REQUEST NOTICE

TITLE ELEM. DIAGRAM
MOV-LCV-1100C & E

Location SAN ONOFRE NUCLEAR GEN. STA.
 ELEMENTARY DIAGRAM
 MOV LCV 1100C
 (VOLUME CONT. TANK DISCH.)
 Southern California Edison Company SCE

5151028-5

SCHEME NO. 1B2A76

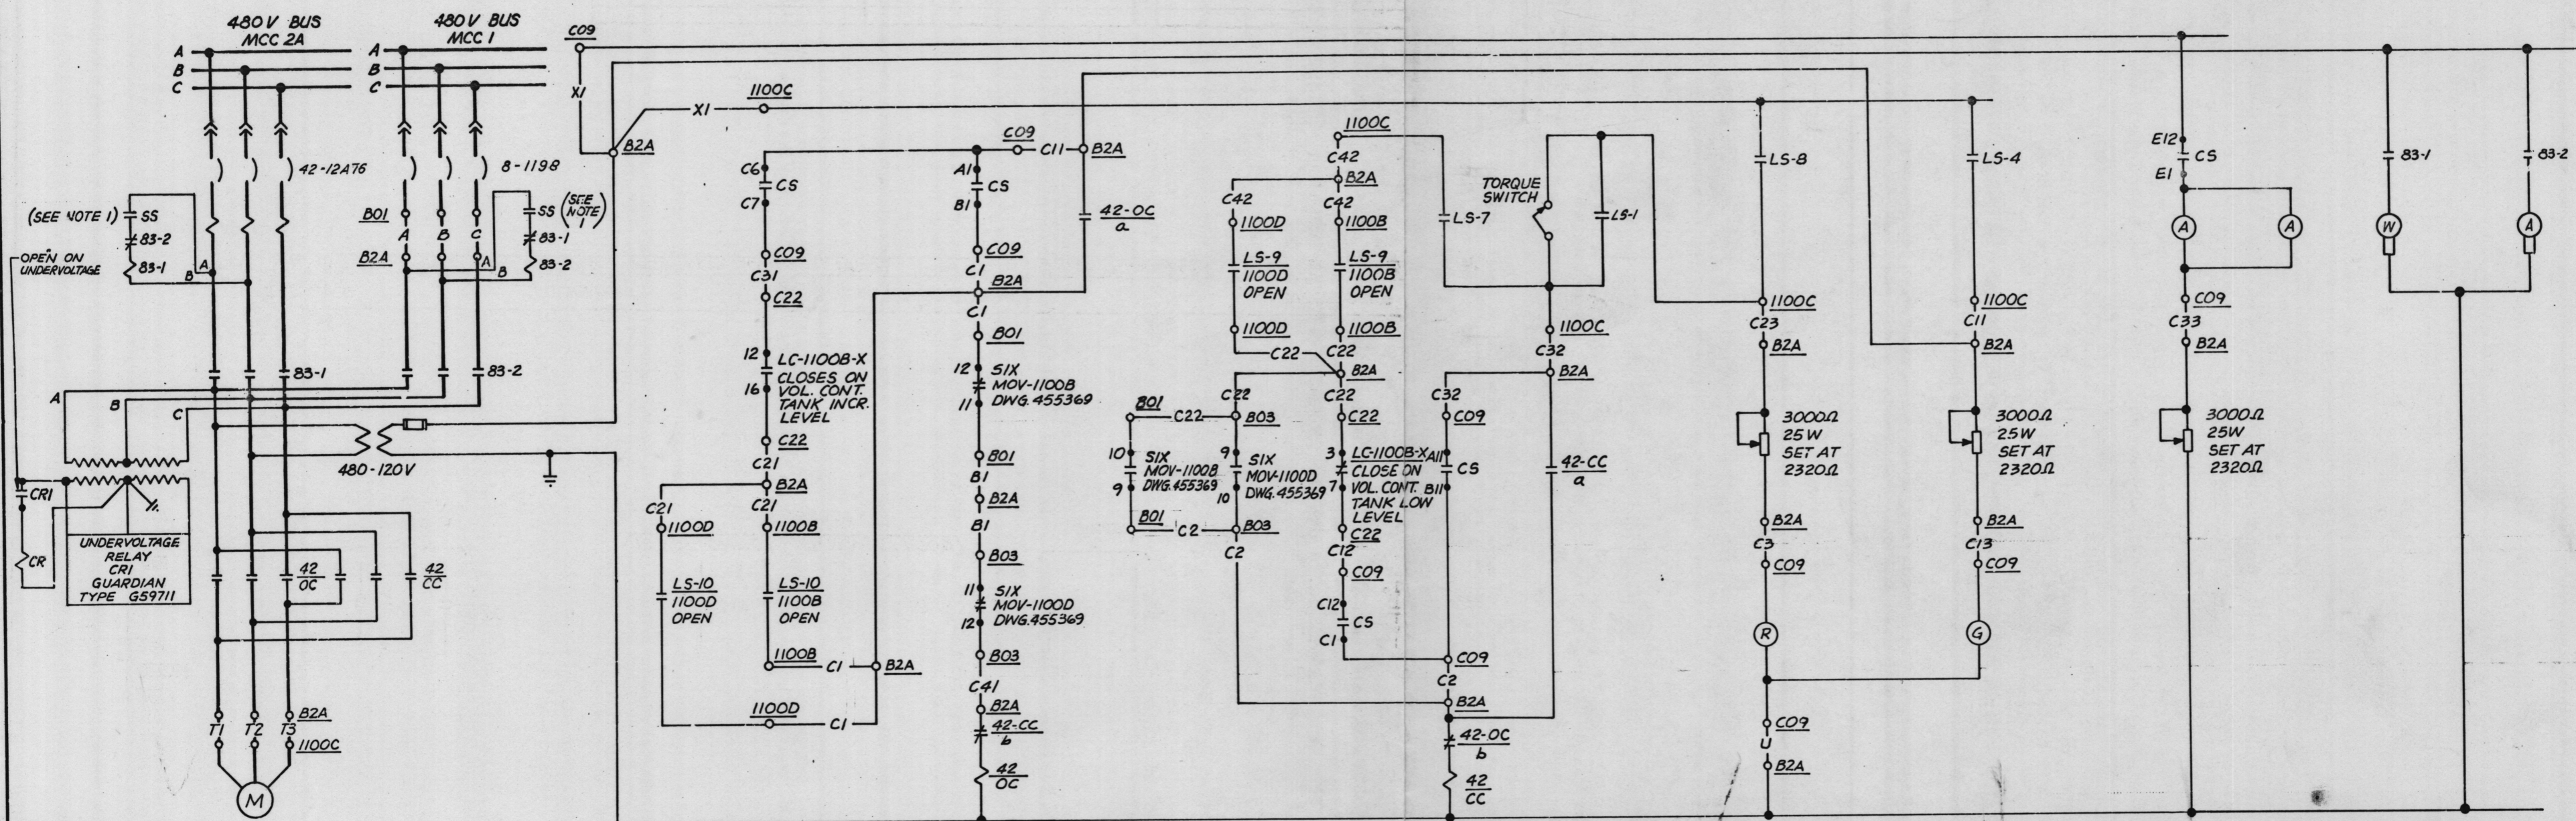
(1) ADDED "E" ON TITLE BLOCK & "VOLUME CONTROL TANK DISCHARGE MOV-LCV-1100E, 1FBO1B3, 42-11B3, LOCATION B2A, C09, C22, B01, C49, B02, INTERLOCKS MOV-LCV-1100D, LS-9, LS-10, SIX 9 & 10, 11 & 12, MOV-LCV-1100B, LS-9, LS-10, SIX 9 & 10, 11 & 12, DEVICE LC-1100B-X (12-16), (3-7); AB(6-9), (1-7) & HEATERS BRKR. NO. 8-12A07 & 8-413 ON EQUIP. TABLE.

(3) CHANGED SCHEME NO. 1B2A76 TO 1GB2A76 & DWG. 455369 TO 5154354

(4) REMOVED 480V BUS MCC, 42-12A76, 8-119B, B01, B2A, B3-1, B3-2, SS, RELAY CRI, CR, TRANSF., CONTACTS LS-10(1100B), SIX (11-12), (9-10), B03, LS-9(1100B), LIGHTS (W) & (A), CONTACTS CR(4-5), LS-9, B3-1(3-4), B3-2(7-8), SEL. SW. SS, # NOTE NO 1; WIRE NOS. A, B, C, C1, C21, B1, C41, C2, C22, C42, S1, K62, C22, C12; LOC. K01, B2A, A1C & A2C.

AFTER
Drwg. # 5151028-5
CON # 10
Sheet # 2 of 2

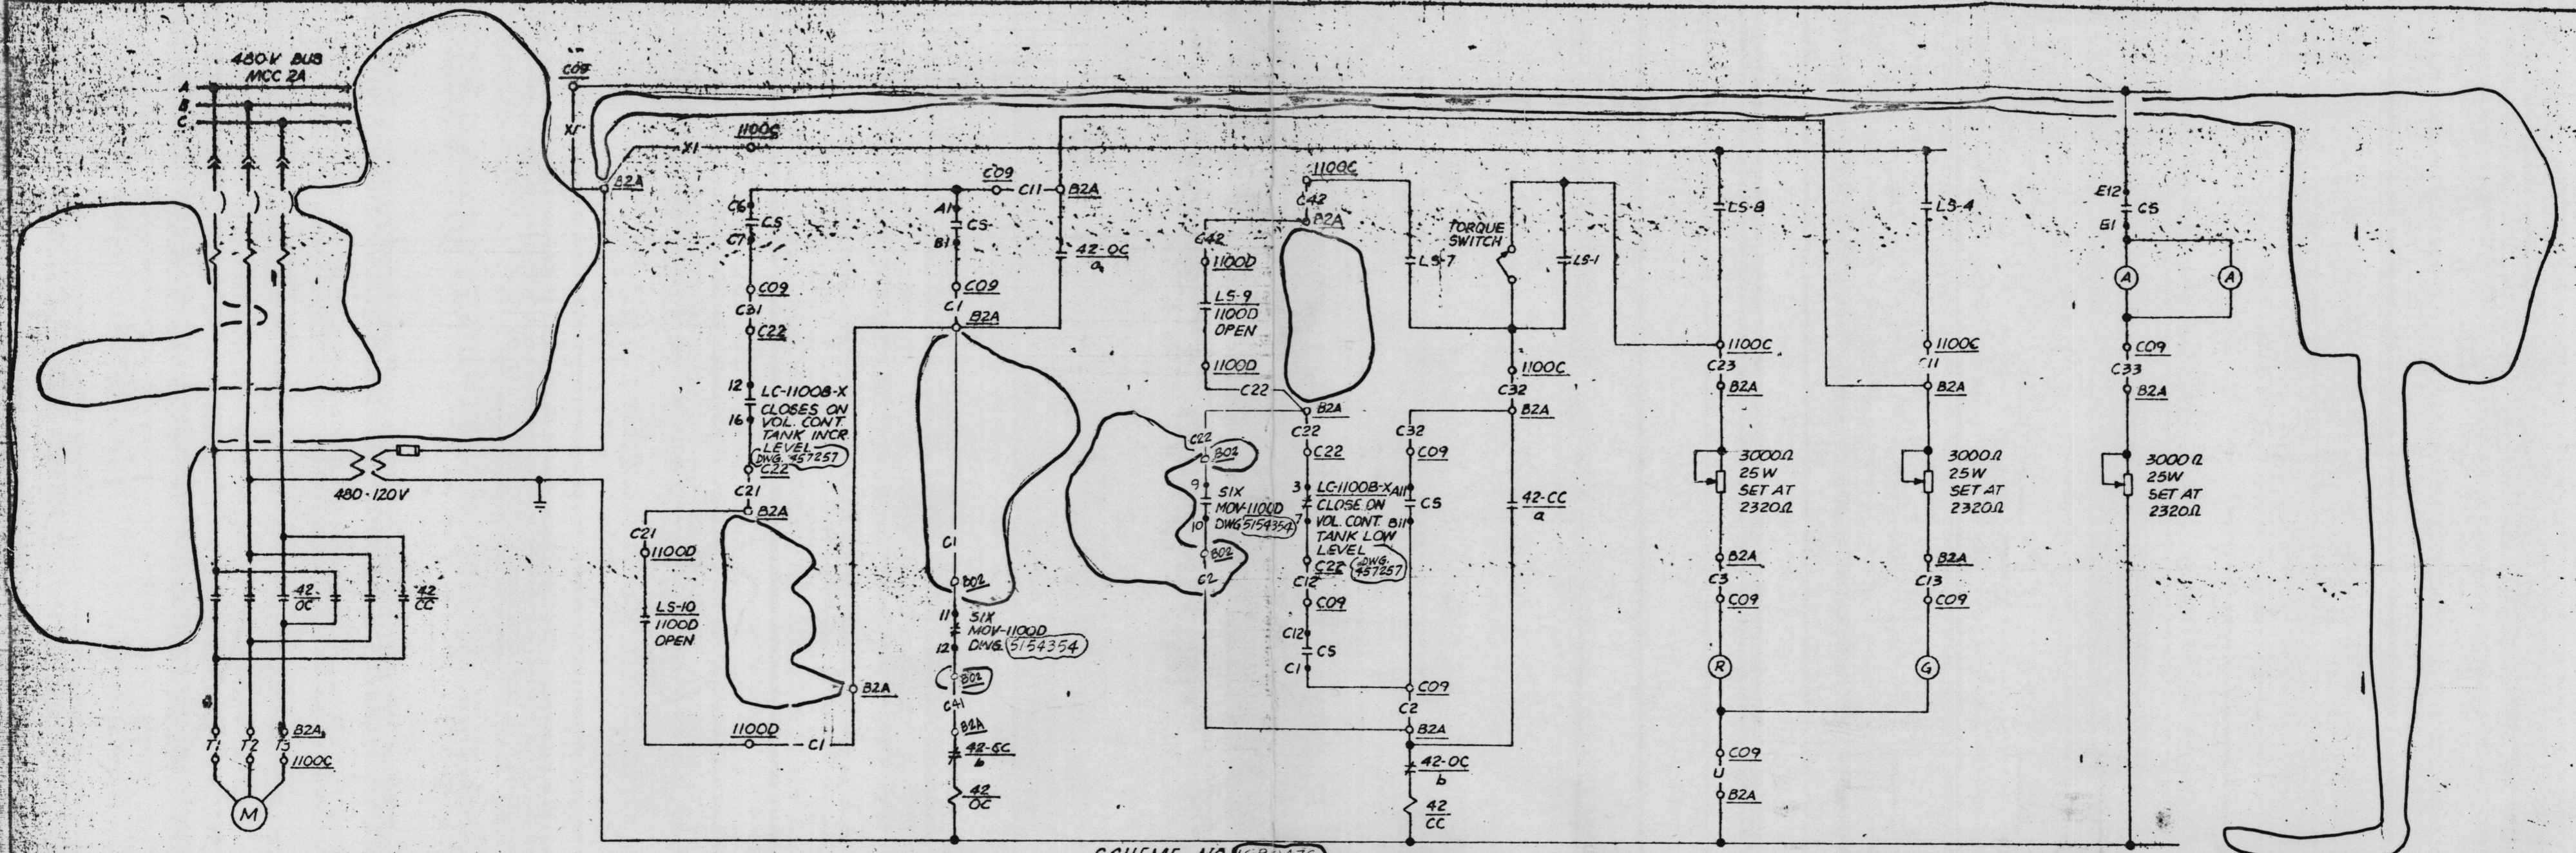
(2) ADDED REF. DWGS. 457253, 457254, 5102166 & 5102169

OTHER AFFECTED DWGS: 5150626. (5) ADDED CONTROL SW CS(HS-1100E, EFFECTIVITY DATE: IMMEDIATELY & "HS-1100C"

SFA-1
TO PROVIDE INDEPENDENT & REDUNDANT POWER TRAINS FOR MOV-LCV-1100C & MOV-LCV-1100E
